Norwell Solar Farm Steering Group

Application by Elements Green Trent Limited for an Order Granting Development Consent for the Great North Road Solar and Biodiversity Park – project ref. EN010162

Deadline 4. Response to the Examining Authority's Second Written Questions (ExQ2)

EXQ2. Climate change and sustainability

Last 7 Days

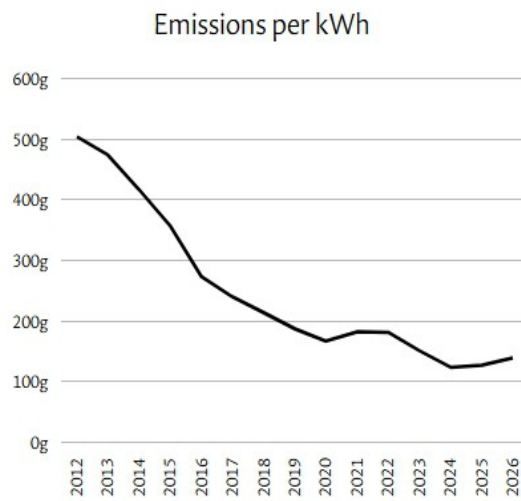
- 10 To calculate the emissions savings resulting from the BESS discharge to grid, the factor of 365gCO₂/kwh is still adopted for all 40 years in the latest Technical Appendix A15.1 [REP3-063](#) (page 53, Table A15.1.21). On page 50 in Table A15.1.20, a factor 207gCO₂/kwh is used to calculate solar PV carbon savings direct to grid, again for every one of the 40 years.
- 11 The Group would argue that there is virtual certainty that these calculated predictions should be dismissed and no reliance placed upon them.
- 12 To illustrate this, below is the latest data from the National Grid showing the reduction in grid carbon emissions:

- 13 The above data must provide a degree of certainty that the Applicant's factors in the 2 aforementioned tables have no place in attempting to calculate the likely effects of the development. Certainly the use of 365gCO₂/kwh for 40 years cannot be justified.
